Accessibility Survey

City of Downey Suva Street & Bluff Road/ Foster Bridge Boulevard

Suva Street & Bluff Road/ Foster Bridge Boulevard Downey, CA 90242

Date of Inspection 6/23/2017

Top Landing

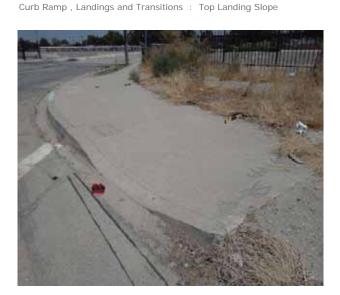
The slope at the top landing is greater than allowed.

On-Site Finding 5.30 percent

Provide a top landing surface that does not exceed the maximum slope and cross slope. Provide a sufficient maneuvering clearance that does not accumulate water.

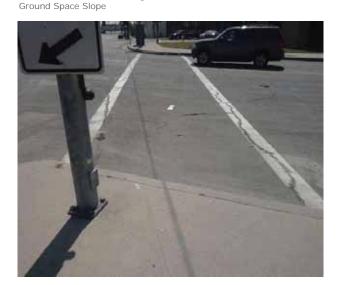
The clear ground space is not level.

On-Site Finding 3.40 percent

Provide compliant level clear ground space at the control.

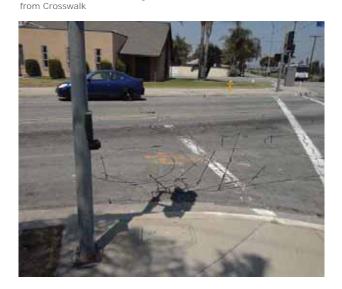
Push button distance from crosswalk is not compliant.

On-Site Finding 136.00 inches

Provide a compliant push button.

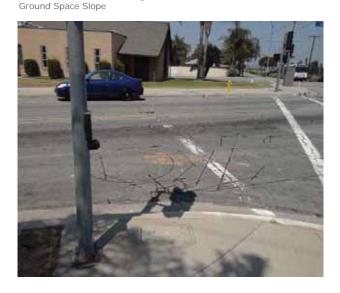
The clear ground space is not level.

On-Site Finding 4.20 percent

Provide compliant level clear ground space at the control.

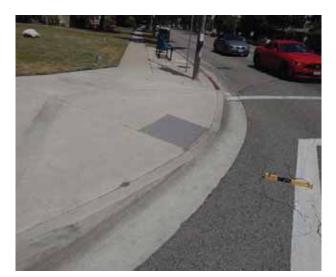
The bottom landing of the curb ramp is on the street, and the slope of the bottom landing is not compliant.

On-Site Finding 7.00 percent

Ensure the bottom landing slope is compliant and provides a smooth transition.

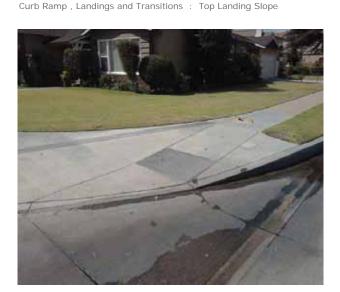
The slope at the top landing is greater than allowed.

On-Site Finding 3.00 percent

Provide a top landing surface that does not exceed the maximum slope and cross slope. Provide a sufficient maneuvering clearance that does not accumulate water.

Change in Level East of City of Bell Gardens @ 33.965588353837, - 118.136711865664

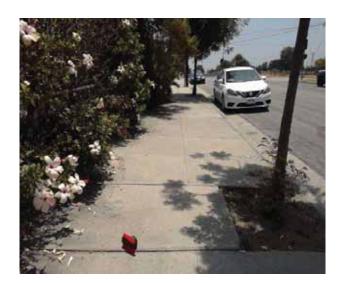
There is a change in elevation greater than recommended value.

On-Site Finding 0.50 inches

Ensure that the change in elevation is within the recommended value.

Change in Level West of Bluff Road @ 33.965612823910, -118.137136995792

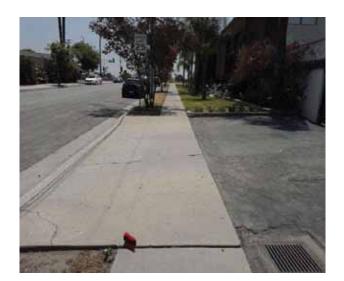
There is a change in elevation greater than recommended value.

On-Site Finding 0.50 inches

Ensure that the change in elevation is within the recommended value.

Change in Level West of Bluff Road @ 33.965636181701, -118.137205392122

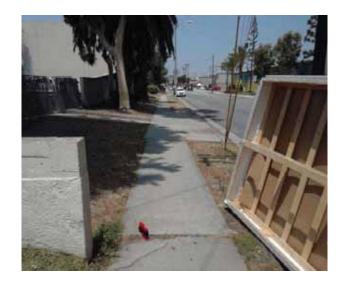
There is a change in elevation greater than recommended value.

On-Site Finding 1.25 inches

Ensure that the change in elevation is within the recommended value.

Change in Level West of Guatemala Avenue @ 33.965206842233, - 118.136157989502

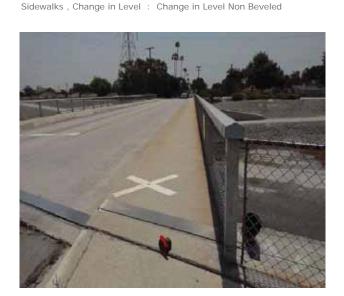
There is a change in elevation greater than recommended value.

On-Site Finding 1.25 inches

Ensure that the change in elevation is within the recommended value.

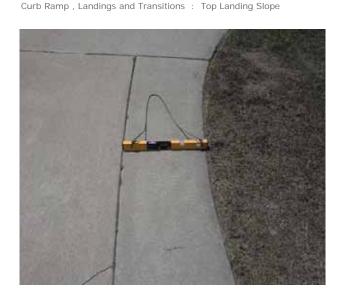
The slope at the top landing is greater than allowed.

On-Site Finding 3.40 percent

Provide a top landing surface that does not exceed the maximum slope and cross slope. Provide a sufficient maneuvering clearance that does not accumulate water.

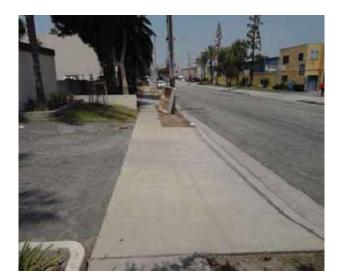
There are no detectable warnings where the pedestrian route crosses vehicular traffic.

On-Site Finding Not Found

Provide detectable warnings.

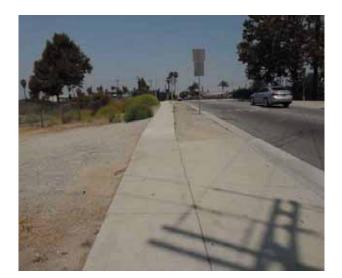
There are no detectable warnings where the pedestrian route crosses vehicular traffic.

On-Site Finding Not Found

Provide detectable warnings.

Change in Level East of Guatemala Avenue @ 33.963361547668, -118.132250010967

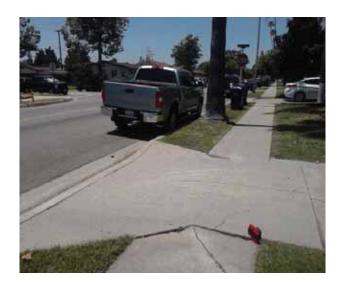
There is a change in elevation greater than recommended value.

On-Site Finding 1.12 inches

Ensure that the change in elevation is within the recommended value.

Change in Level West of Horley Avenue @ 33.963101267817, -118.132093101740

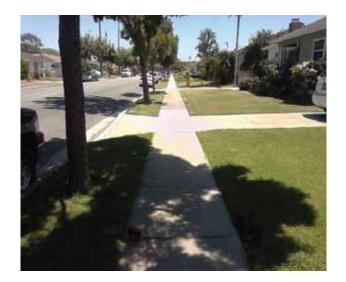
There is a change in elevation greater than recommended value.

On-Site Finding 0.50 inches

Ensure that the change in elevation is within the recommended value.

Change in Level West of Wiley Burke Avenue @ 33.963442745920, - 118.132774382830

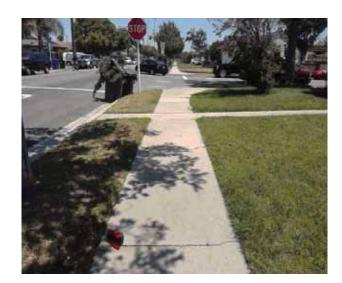
There is a change in elevation greater than recommended value.

On-Site Finding 0.62 inches

Ensure that the change in elevation is within the recommended value.

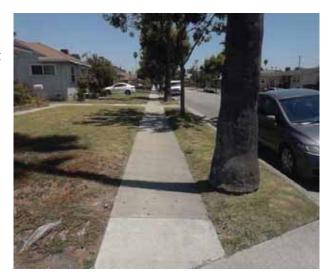
Sidewalk cross slope is not compliant.

On-Site Finding 4.50 percent for 343.00 feet

Repave the sidewalk surface with the recommended cross slope.

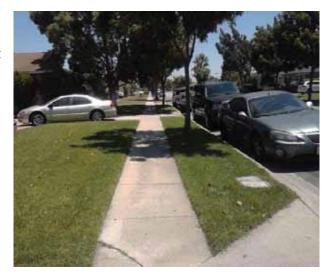
Sidewalk cross slope is not compliant.

On-Site Finding 7.90 percent for 134.00 feet

Repave the sidewalk surface with the recommended cross slope.

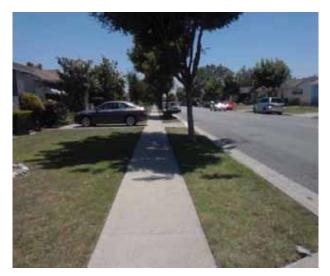
Sidewalk cross slope is not compliant.

On-Site Finding 5.00 percent for 361.00 feet

Repave the sidewalk surface with the recommended cross slope.

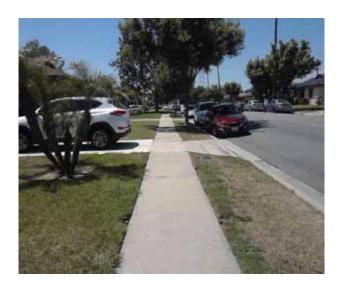
Sidewalk running slope is not compliant.

On-Site Finding 6.00 percent for 4.00 feet

Repave the sidewalk surface with the recommended running slope.

Change in Level East of Horley Avenue @ 33.962018984511, -118.129585236311

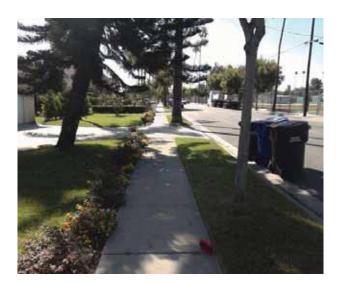
There is a change in elevation greater than recommended value.

On-Site Finding 0.50 inches

Ensure that the change in elevation is within the recommended value.

Change in Level East of Samoline Avenue @ 33.960114666376, -118.125586062670

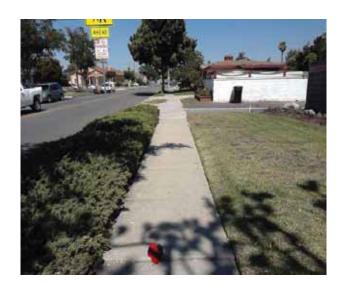
There is a change in elevation greater than recommended value.

On-Site Finding 0.75 inches

Ensure that the change in elevation is within the recommended value.

Change in Level West of Rives Avenue @ 33.962099071723, -118.130102902651

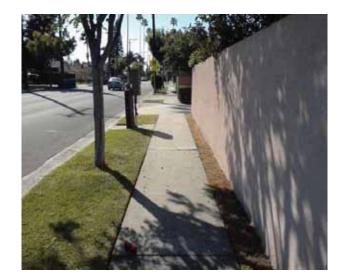
There is a change in elevation greater than recommended value.

On-Site Finding 0.50 inches

Ensure that the change in elevation is within the recommended value.

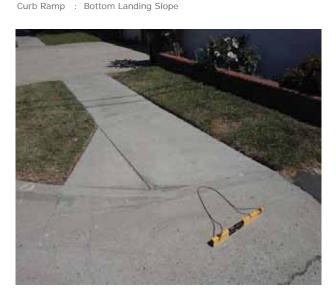
The bottom landing of the curb ramp is on the street, and the slope of the bottom landing is not compliant.

On-Site Finding 5.80 percent

Ensure the bottom landing slope is compliant and provides a smooth transition.

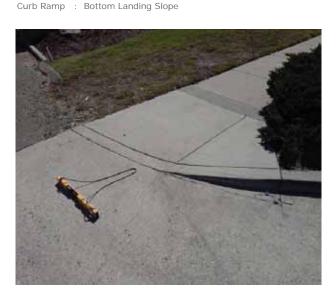
The bottom landing of the curb ramp is on the street, and the slope of the bottom landing is not compliant.

On-Site Finding 6.30 percent

Ensure the bottom landing slope is compliant and provides a smooth transition.

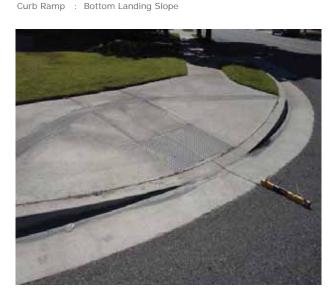
The bottom landing of the curb ramp is on the street, and the slope of the bottom landing is not compliant.

On-Site Finding 6.40 percent

Ensure the bottom landing slope is compliant and provides a smooth transition.

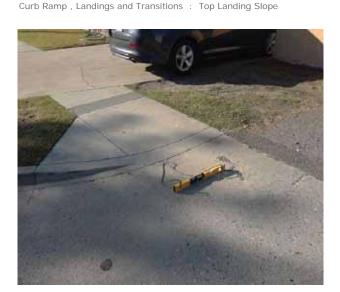
The slope at the top landing is greater than allowed.

On-Site Finding 2.60 percent

Provide a top landing surface that does not exceed the maximum slope and cross slope. Provide a sufficient maneuvering clearance that does not accumulate water.

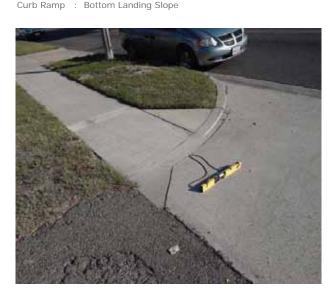
The bottom landing of the curb ramp is on the street, and the slope of the bottom landing is not compliant.

On-Site Finding 5.80 percent

Ensure the bottom landing slope is compliant and provides a smooth transition.

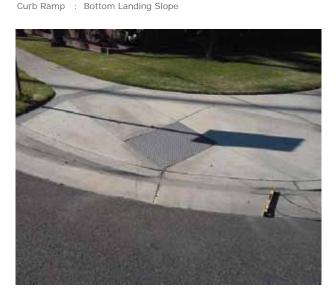
The bottom landing of the curb ramp is on the street, and the slope of the bottom landing is not compliant.

On-Site Finding 7.50 percent

Ensure the bottom landing slope is compliant and provides a smooth transition.
